Millstone Nuclear Power Station, Unit No. 2
Reply to Request for Additional Information on Spent Fuel Storage Capacity

Attachment No. 1

Response to Request for Additional Information on
Spent Fuel Storage Capacity

FLAME NUMBER
Figure 1

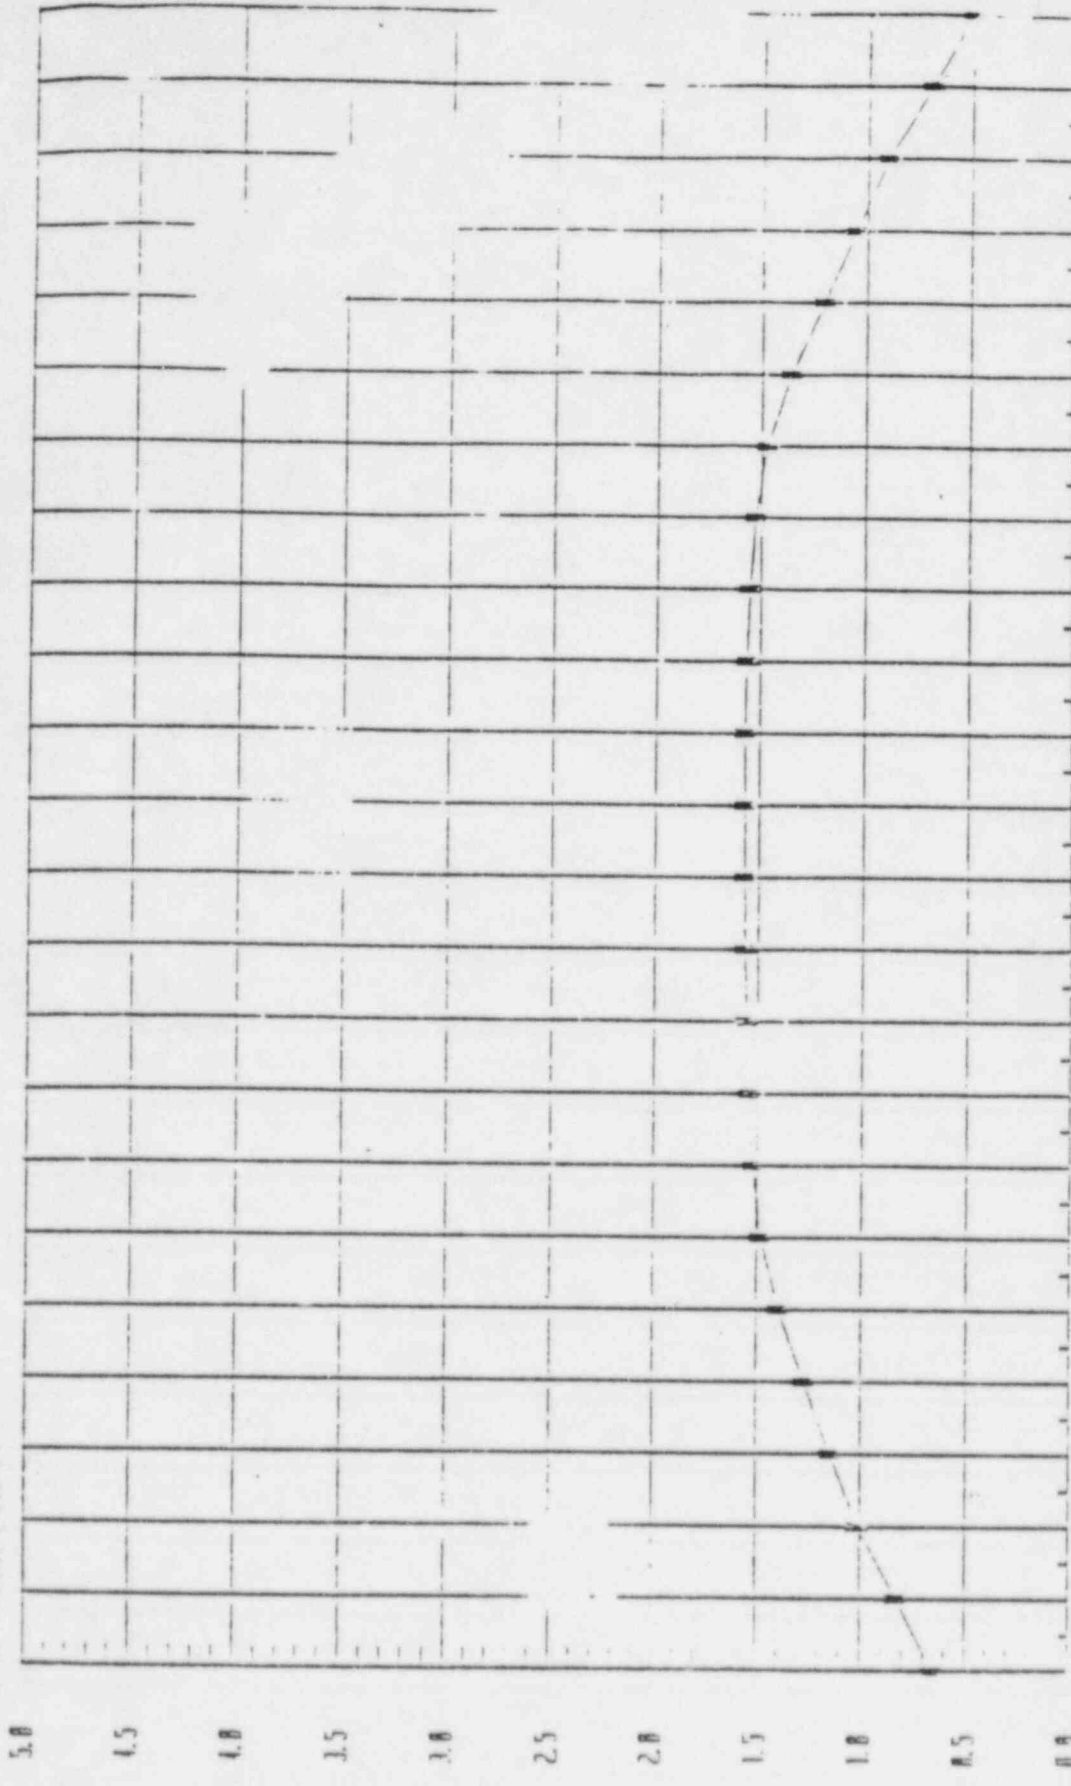
You have not described or provided detailed results of the benchmark calculations for your methods which provide values of uncertainties and biases when calculating (1) fuel parameters including burnup, (2) your fuel pool configurations, (3) boron as used in Region I, (4) burnup effects as in Region II. Please describe these analyses and their applicability to your configurations and parameters, and present relevant results and conclusions on uncertainties. In particular, discuss the effects of axially non uniform burnups and reactivity parameters and their uncertainty (including extreme ranges which might be encountered). If some of this information has been presented (and approved) in other applications these may be referenced, but include a summary, basis for applicability, and results for your configurations.

The maximum reactivity change due to the axial burnup shape was determined by analyzing the two extreme axial shapes that have been observed in reactor core analysis (cosine axial shape, and a flat distribution). The two extreme distributions were picked from axial shapes taken from reactor core analysis; as expected, the cosine-like shape occurred at the end of Cycle I as shown in Figure 1. The flattest distribution occurred at the end of what is considered an equilibrium cycle (Figure 2). The axial average for both of these burnup shapes

was calculated. The average burnup became the uniform burnup case, which did not take into consideration the axial shape. The reactivity was calculated for both the uniform burnup and the actual burnup profiles (Figure 1 and 2). The effective multiplication factors were calculated using KENO assuming the entire Region II rack was full of fuel with the same burnup shape. The effective multiplication factors obtained using the KENO code are as follows:
